# Ulster County Planning Board

## RECOMMENDATION

REFERRAL NO: 2025-006

### Re: Route 9W Multifamily Development

FIGURE 3.14: ADAMS FAIRACRE FARMS/ GRANT AVENUE  
CONNECTOR CONCEPT

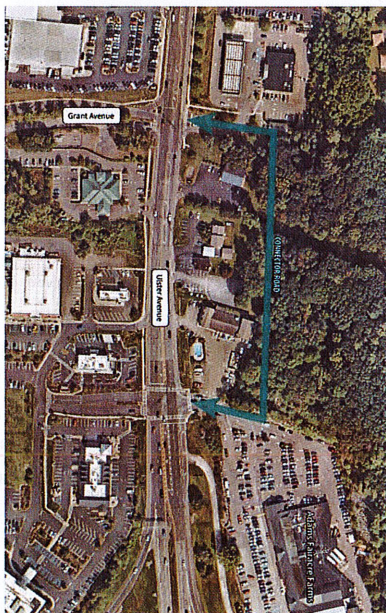
One alternative would be implementing the Ulster County Transportation Council's recently completed final Route 9W Mobility Plan draft. The plan includes specific ideas that address these goals for the proposed development area, as shown in Figure 3.14, which is an

example of access management “to connect the Grant Avenue and Adams Fairacre Farms signals via a connector road that runs behind the Aqua Jet Pools and Jolly Cow properties. This proposed connector road would allow customers to utilize the existing signals, eliminating the need for left turns at mid-block locations. Likewise, the new connector road could serve as the primary access for these businesses, enabling driveways along Route 9W to be removed or restricted to right-in/right-out without limiting access. This would provide a benefit to pedestrians in the corridor and also allow for streetscape improvements. Further, the new connector road would help shape future development patterns and limit traffic impacts by allowing for a denser road network.” This may have some difficulties due to grades.

The UCPB finds the current proposed access plan problematic at best. Alternative access routes per the Route 9W Mobility Study or changes to the existing access point that can reduce queues and turning movement conflicts are recommended to be developed. Any alternative will require coordination with adjacent property owners, whether via the connector road as shown or via a linkage of access to the proposed solar farm to the North with Tuttyenbridge Road or a redesign of the existing access. Without an effective access point(s), the UCPB cannot support this project’s development. Should an alternative be developed, we recommend that the project be submitted to the Board for consideration. Approval from NYSDOT for this proposed change is required, and transit/school bus access needs to be addressed.
